## Safety Alert: Hydraulic Hoist Cylinder Failure on Komatsu 680-E Trucks

Hoist Cylinder Failure

**EQUIPMENT:** All 445E, 510E, 630E, AND 685E HAULPAK® Trucks with "Super Cylinder" Hoist Cylinders

**SUBJECT:** Product Improvements to Hoist Cylinders

FIGURE 1. CYLINDER, 3rd STAGE

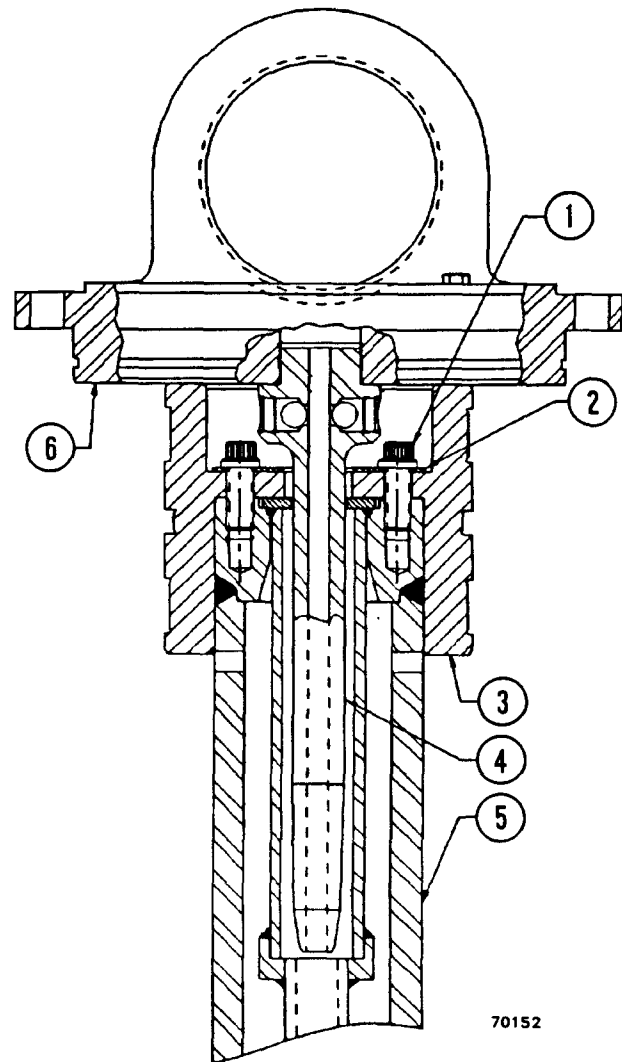
The Hoist Cylinder Rework Kits, MK3567 for the 630E and 685E and MK3569 for the 445E and 510E, provide the parts and instructions for improving the method of retaining the third stage piston bearing retainer. On existing cylinders, the retainer is held by six 5/8" UNC grade 8 hex head capscrews with hardened flat washers. The new method uses twelve 5/8" UNRC grade 9, twelve point capscrews (1, Figure 1) and a single, hardened washer plate (2). This provides a significant increase in the clamping force exerted on the piston bearing retainer (3).

When a cylinder is disassembled, the Rod Eye Structure (5) should be modified according to rework drawing ED5217 for the 630E/685E or ED5201 for the 445E/510E which adds six more tapped holes. When reworking the Rod Eye Structure, plug all external piston openings to prevent internal contamination. A new bearing retainer ED5224 will be required (3). The quill assembly (4) must be removed from the cylinder head (6) and chamfered as shown on rework drawing ED5219. After modification, the following parts should be renumbered with the same part numbers as used in the production cylinders, but with a prefix "R" in front of the number to indicate a reworked part.

1. Make certain threads on capscrews and threads in rod eye structure are clean and dry (free of oil and solvent).
2. Using Loctite 'LOCQUIC' Primer "T" (TL8753, or equivalent), spray mating threads on capscrews and threads in rod eye structure.

3. Apply Loctite Sealant #277 (VJ6863, or equivalent) to mating threads of both capscrews and threads in the rod eye structure.
4. Install capscrews (1, Figure 4) and hardened washer plate (2) and tighten capscrews to 250 ft. lbs. (209 N.m) torque.

Allow parts to cure for 2\* hours before exposing threaded areas to oil
